**TECHNICAL BULLETIN
No. 0117****Shift Interlock for
C20 Transmission**

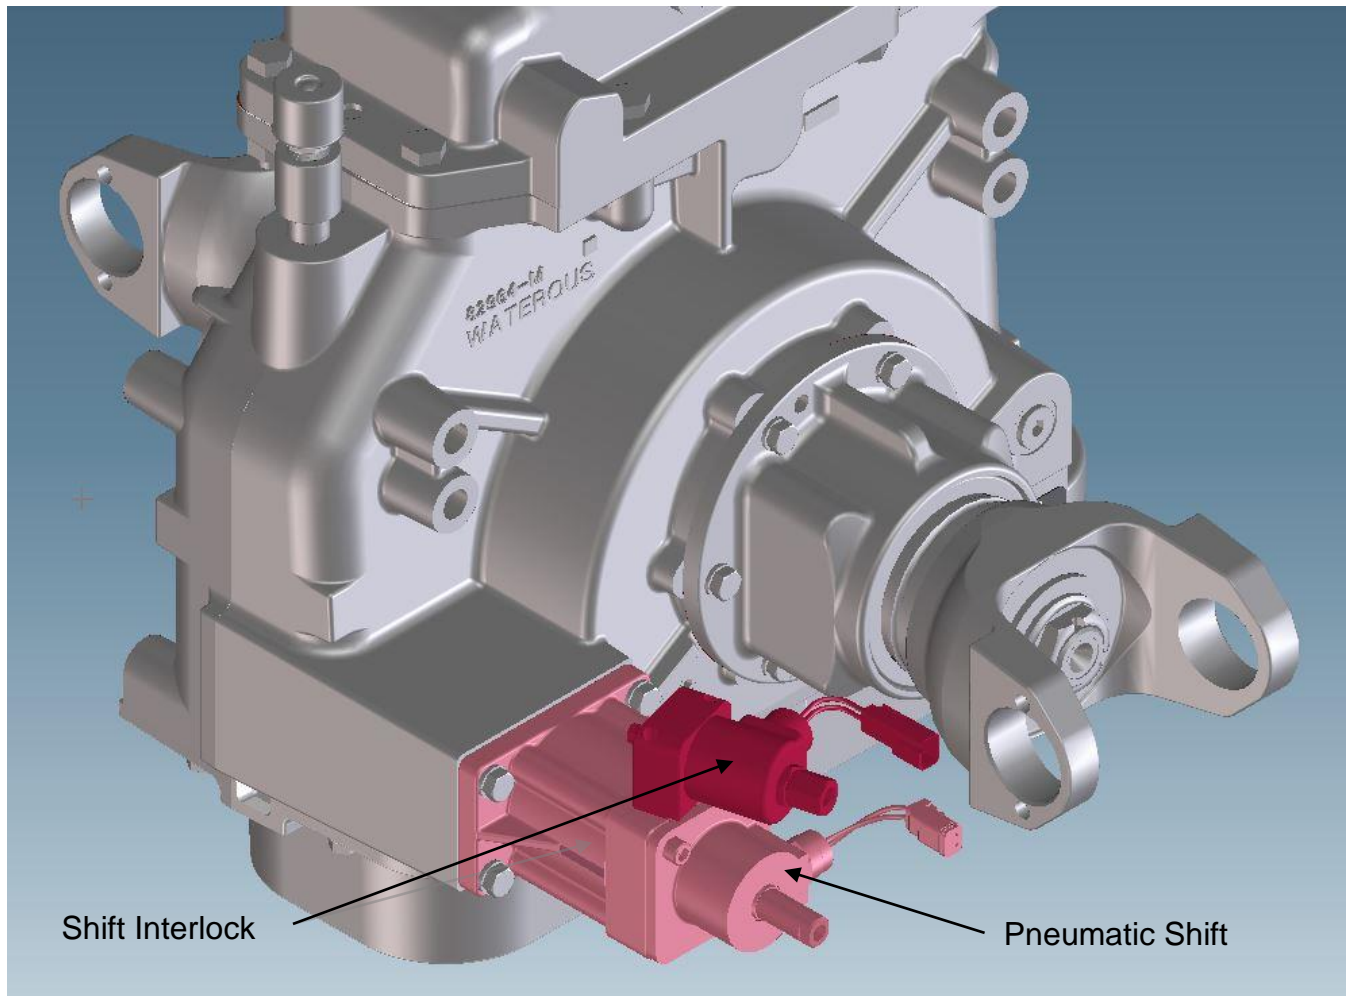
All C20 Transmissions ordered after January 1, 2016 will have the new shift interlock.

NFPA requires a shift interlock as directed by new section 16.10.1.4

Where the pump is driven by the chassis engine and automatic transmission through a split shaft PTO, an interlock system shall be provided to prevent the pump drive system from being shifted out of the "pump engaged" pumping mode of operation when the chassis transmission is in pump gear.

Waterous has developed an interlock system for the pneumatic shift on C20 Transmissions. This will be standard equipment on all C20 transmissions on units ordered after January 1, 2016.
